REVISIONS	
NO.	DESCRIPTION
1	1-6-64 CHANGED GRADE FROM .5% TO .3% STA. 3+32.16 TO 10+32.09. CHANGED M.H. STATIONING. CHANGED MANHOLE TO C.O. NO. 1. A.W. D.A.P. <i>W.D. Hartman</i>
CITY OF RIVERSIDE, CALIFORNIA DEPARTMENT OF PUBLIC WORKS	
PARKVIEW TERRACE SANITARY SEWER DISTRICT	
APPROVED BY <i>William D. Hartman</i> TRAFFIC DIV.	PROJ. NO. 6037
DATE <i>Aug 9 1963</i>	S-356 SHEET 1 OF 1

CITY OF RIVERSIDE, CALIFORNIA  
 DEPARTMENT OF PUBLIC WORKS  
 SEWER PLAN & PROFILE  
 PARK HILL ESTATES

**SEWER PLAN & PROFILE  
 PARK HILL ESTATES**

**PROFILE**  
Scale: Hor. 1" = 30'  
Vert. 1" = 5'

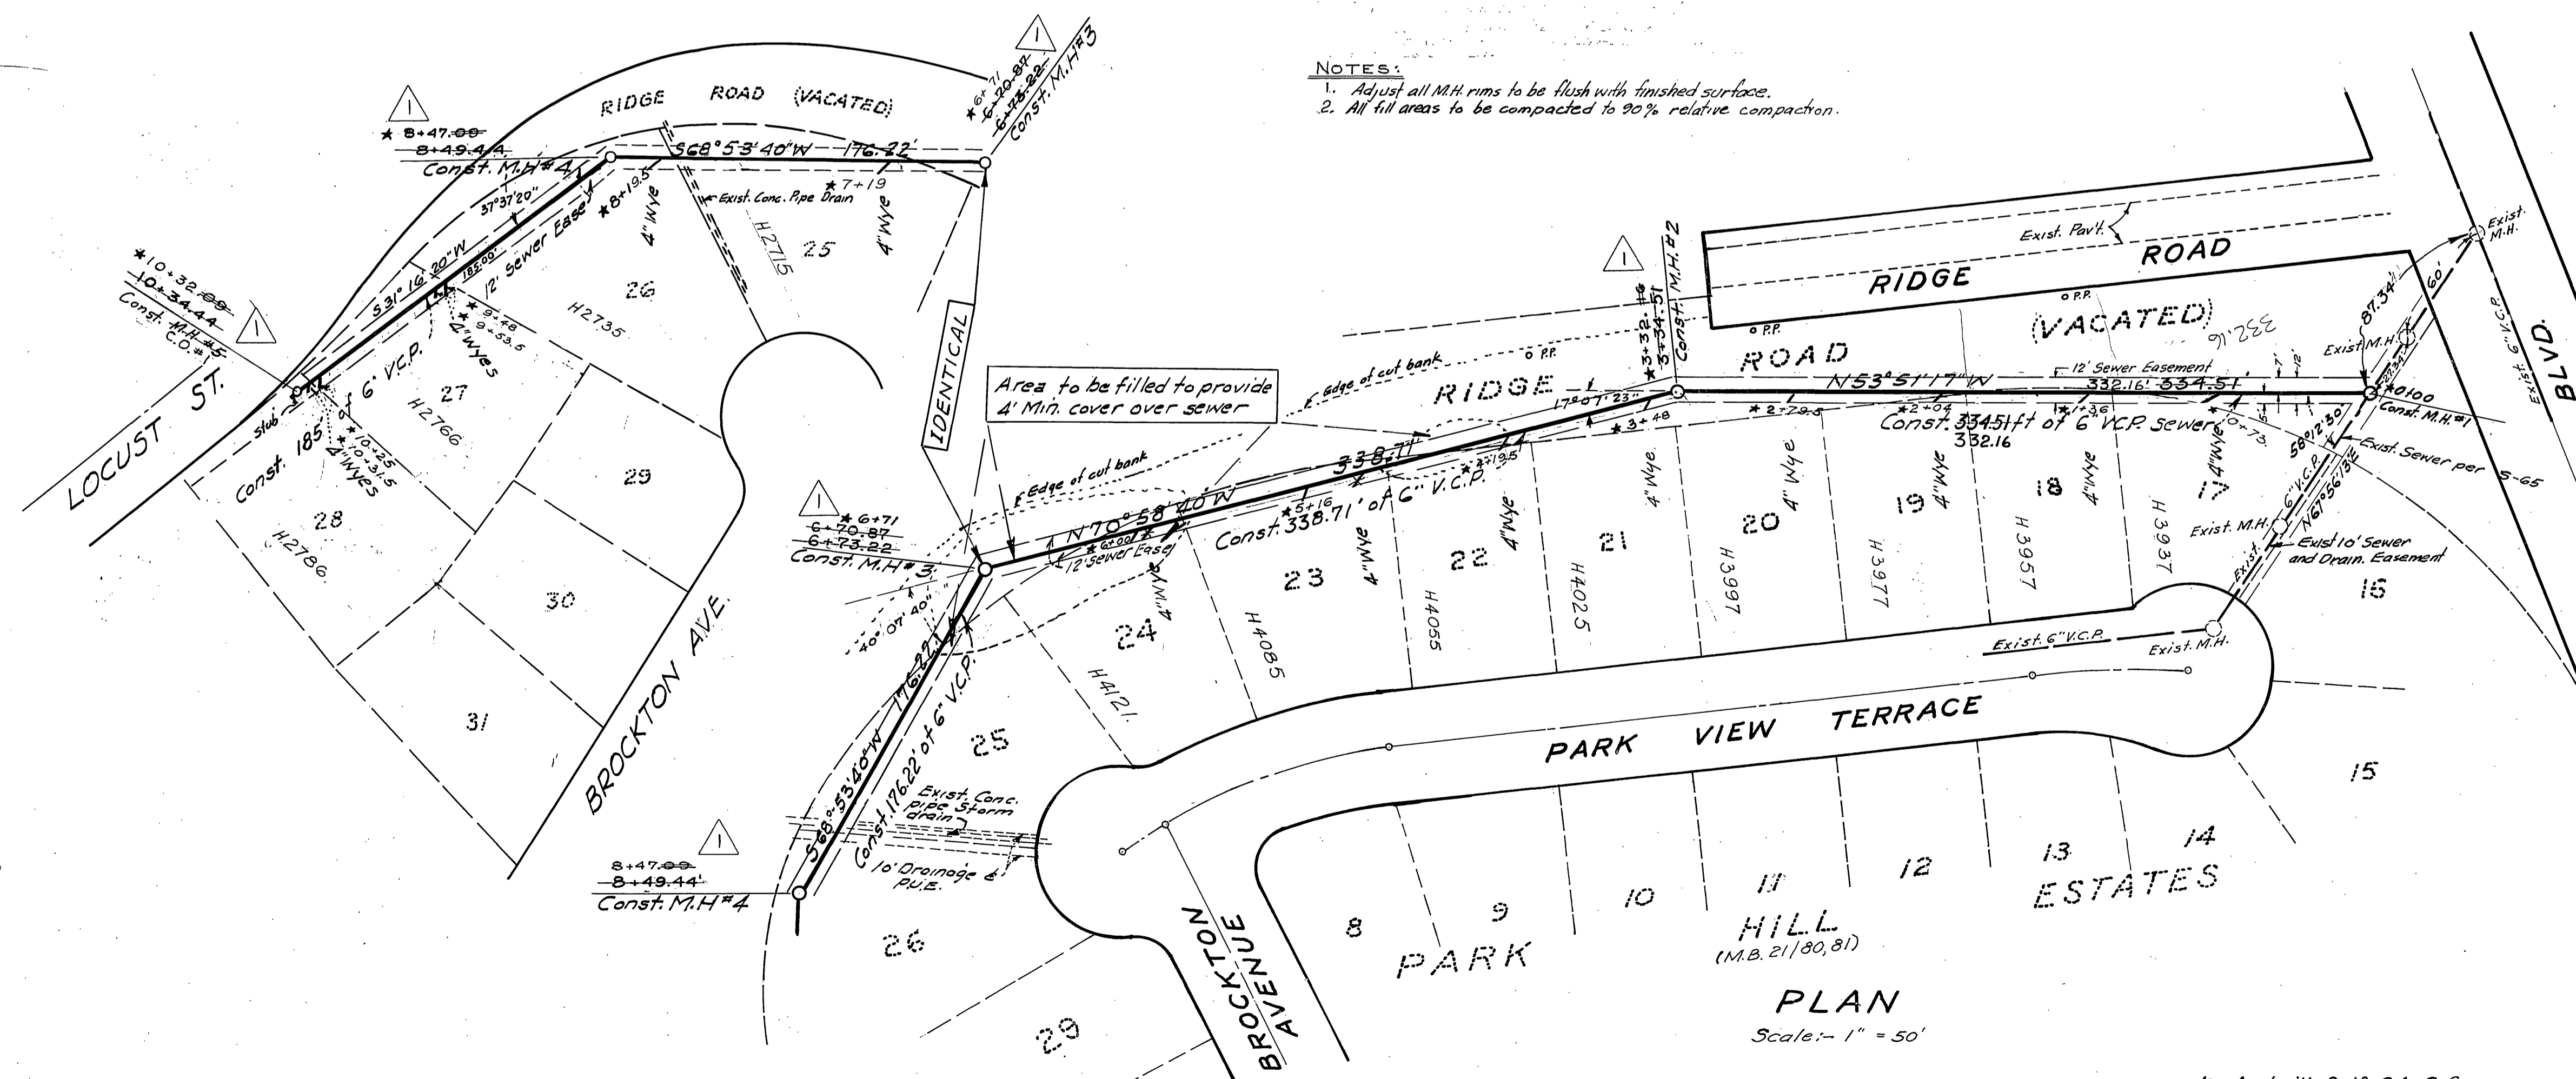
\* = As built 2.13.64. G.S.
